ATTACHMENT 1 TO TXX-06125

RESPONSES TO REQUESTS FOR ADDITIONAL INFORMATION

FOR THE REPLACEMENT STEAM GENERATOR SUPPLEMENT

LOSS OF COOLANT ACCIDENT ANALYSIS METHODOLOGIES

Figure A-1 Primary and Secondary System Pressures – 3-in Break

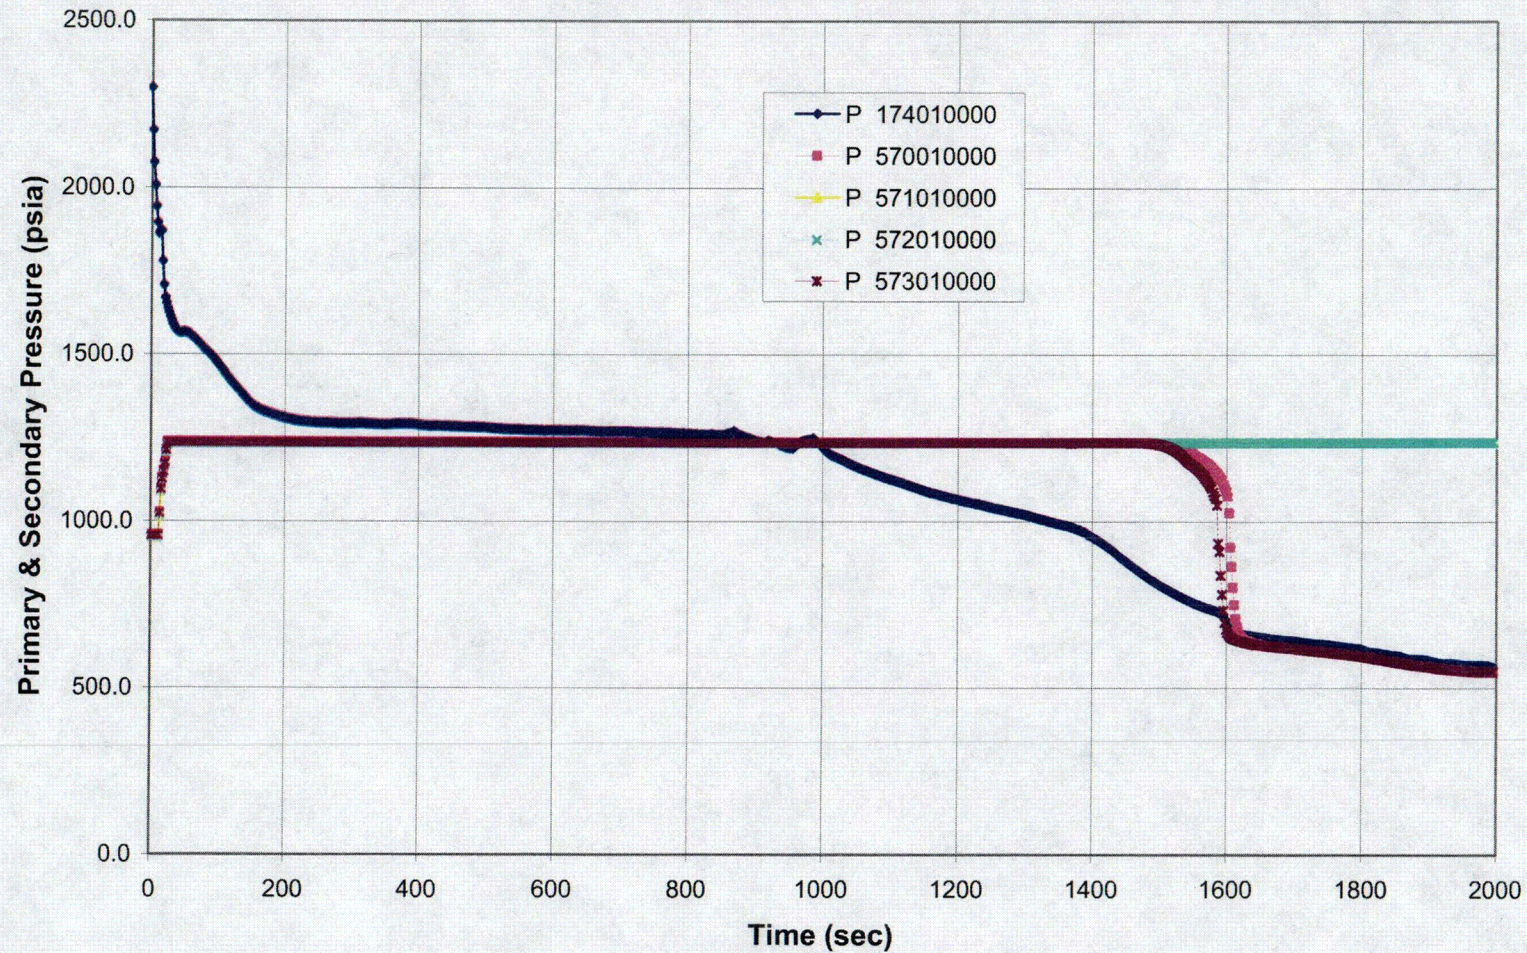
(1) System depressurization rates are relatively fast, even for the smallest breaks, e.g. the 3" break shown in Figure A-1. Even for the smallest breaks, the ultimate rod quench is due to accumulator injection. Thus, the clad temperature turns around very quickly once the relatively high accumulator set point pressure is reached (again see Figure A-1 for the 3" break).

Figure A-7 Hot Assembly Clad Temperatures – 3-in Break

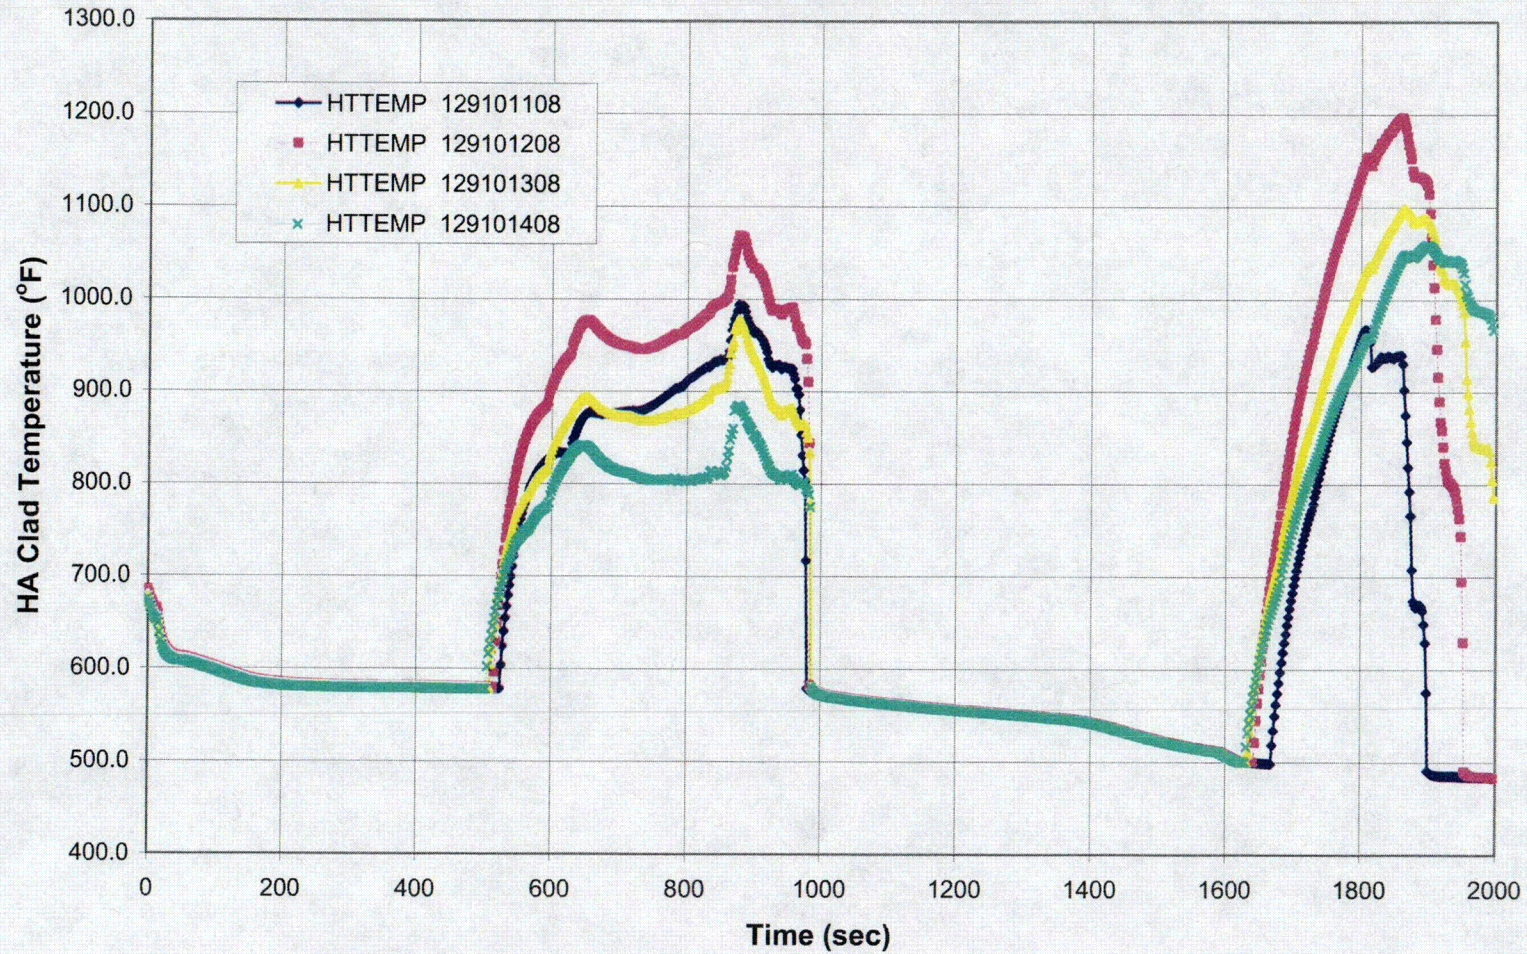
As shown in Figures A-7, B-7, C-7, D-7, E-7, G-7, H-7, I-7, J-7, for breaks of 3", 3.76", 4", 4.22", 5" and various sensitivities, the CPSES SBLOCA clad temperatures increase nearly monotonically¹ and rapidly after CHF in all cases. Mechanisms that might keep the rods at relatively high but constant temperatures, i.e., that would prevent rod temperatures from increasing rapidly in post CHF heat transfer mode are not operative during CPSES SBLOCA for two main reasons:

(2) The limiting power shapes peak very near the top of the core. For the temperatures to linger at relatively high values, the uncovered portion of the core would have to be above the peak node, but below the top of the core. When the level is below the peak power node, the temperature increases at the rates seen in the smaller breaks, e.g., the 3" break shown in Figure A-7. Obviously, if the level is above the top of the core

Figure A-15 Hot Assembly Steam Temperatures – 3-in Break

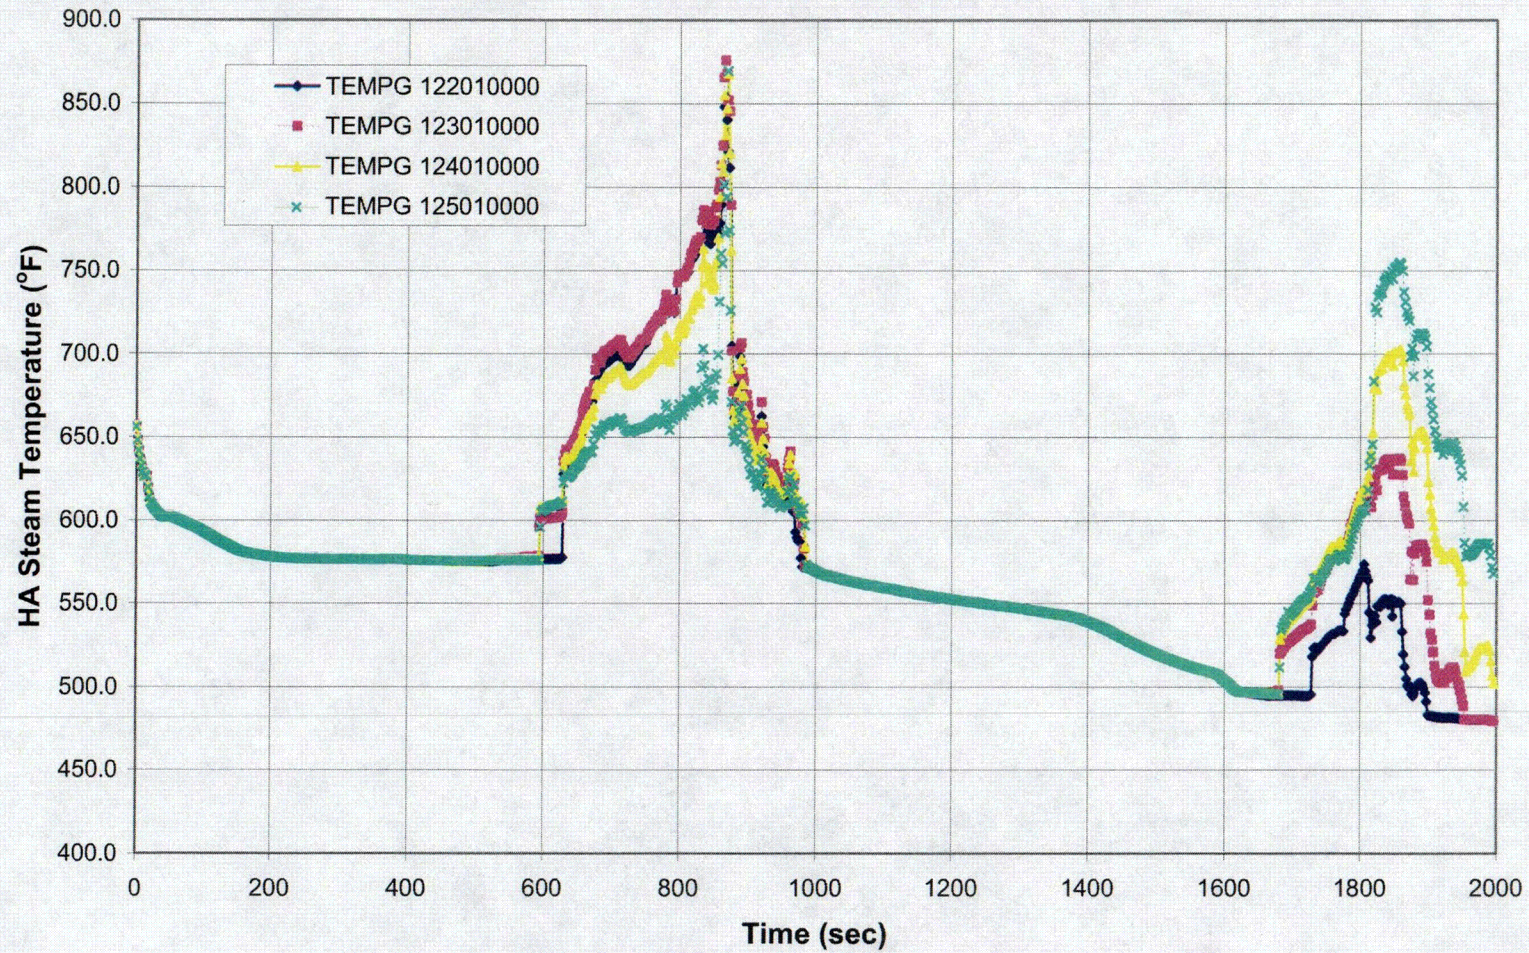
Also, the additional figures requested in Q7.a.iii include the steam temperatures adjacent to the hottest clad temperature nodes. Plots of those temperatures (Figures 15 of the A through J sets, i.e. A-15, B-15... J-15) provided in the section: “COMPLETE SETS OF PLOTS FOR ADDITIONAL CALCULATIONS” show the steam is highly superheated with temperatures following those of the adjacent cladding.

Figure B-7 Hot Assembly Clad Temperatures – 4-in Break

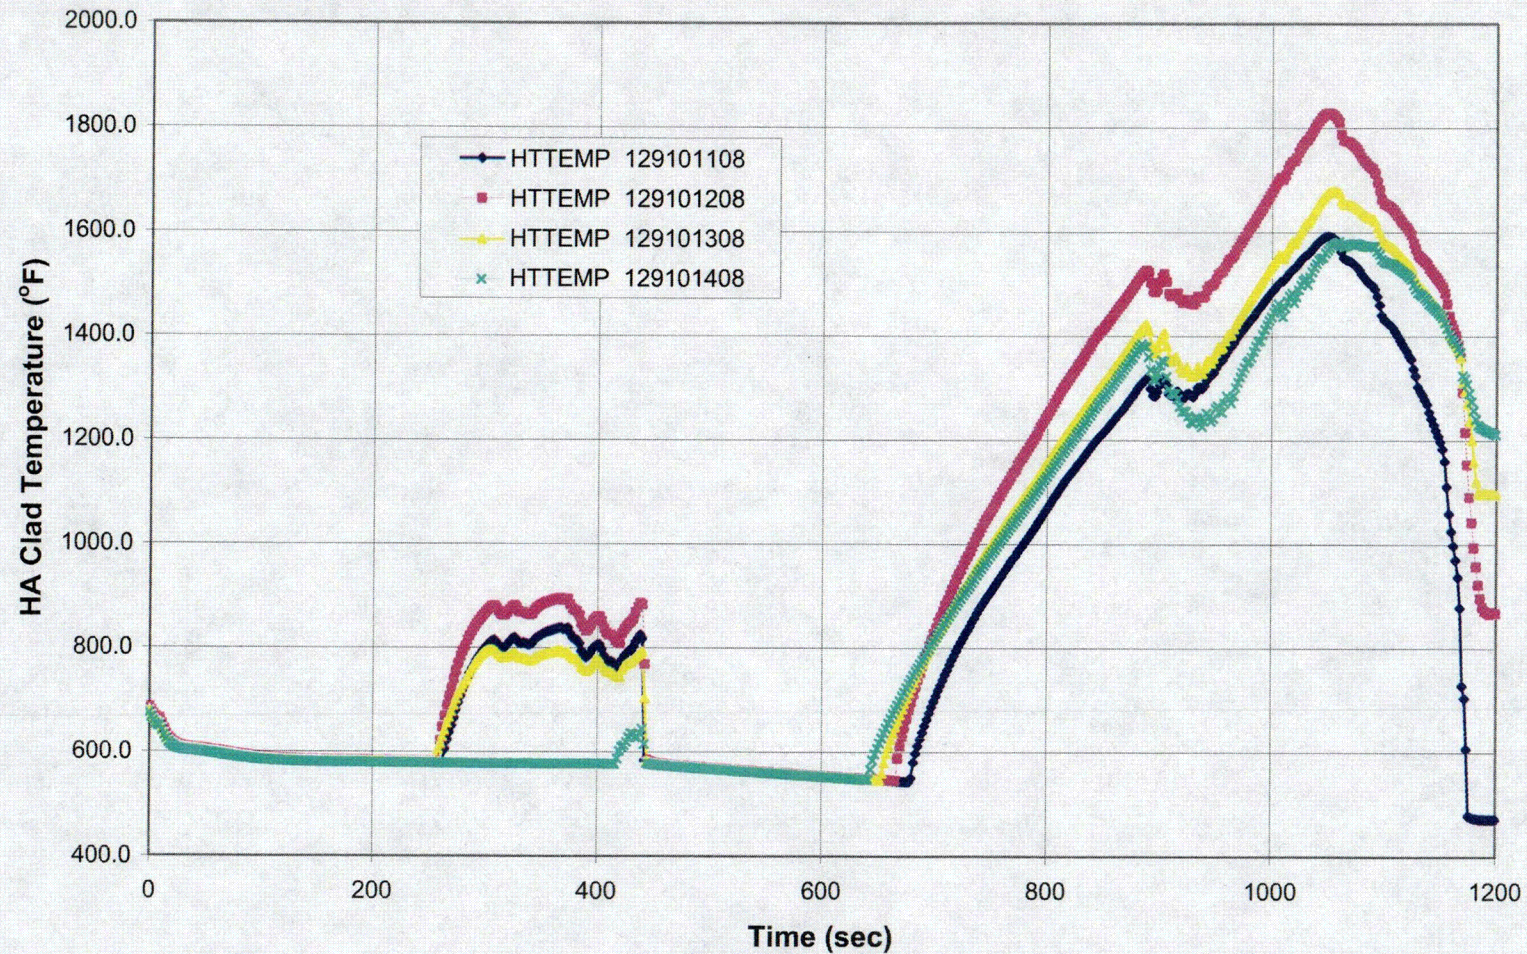
At a June 14 phone call the NRC asked what causes the dip in clad temperature around 900 seconds seen for example in Figure B-7, corresponding to the clad temperatures for the limiting 4inch break base case. This inflection is due to water redistribution between the Hot Assembly, Central Region and Average Core. Figures B-2, B-3 and B-4, respectively, show void fractions at three core elevations: bottom (nodes, 112, 130,150), lowest $\alpha = 1$ elevation (nodes, 122, 140, 160) and an intermediate elevation (nodes, 117, 135, 155) in each of these three core regions. At the time period of interest, around 900 seconds, the topmost elevation (nodes, 122, 140, 160) remain at $\alpha = 1$. This shows that no water has entered either of these three core regions from the top. Further evidence of this is provided in Figure B-5 that shows no liquid at this time in the upper plenum either. Similarly, there is no significant trend change in the void fractions in the lower elevations (nodes, 112, 130,150). Additional inspection of mass flow rates from the lower plenum to the various core regions (flows from volume 111 to 112, 130 and 150) also show no change over the period of interest. These observations indicate there was no change in the amount of water entering these three core regions either from above or from below. A look at the void fraction behavior at the intermediate elevation (nodes, 117, 135, 155) however, is revealing. While similar oscillations in void fraction are seen at that elevation in all three regions, the highest void fractions occur in the average core region, then in the central region and finally in the hot assembly. This hierarchy indicates net water movement away from the larger regions towards the hot assembly at intermediate elevations. A look at representative cross flows during the period of interest shows a step reduction in the outflow from the hot assembly. Figure B-15 shows a reduction in the hot channel superheat about the PCT elevation which is consistent with more of the upstream flow remaining in the hot assembly. Thus, these observations indicate that the inflection in temperature is due to a redistribution of flow between the various core regions, where outflow from the hot assembly region is temporarily reduced to satisfy energy and momentum conservation equations, most likely compensating for an earlier overshoot. Note that the cross flow resistance study (Figure 4.37 of Reference 3) identifies the limiting cross flow resistance. Heat transfer and flow regime flags in the core were examined but no significant changes occurred during the time period of interest that could account for the inflection in the clad temperature history.
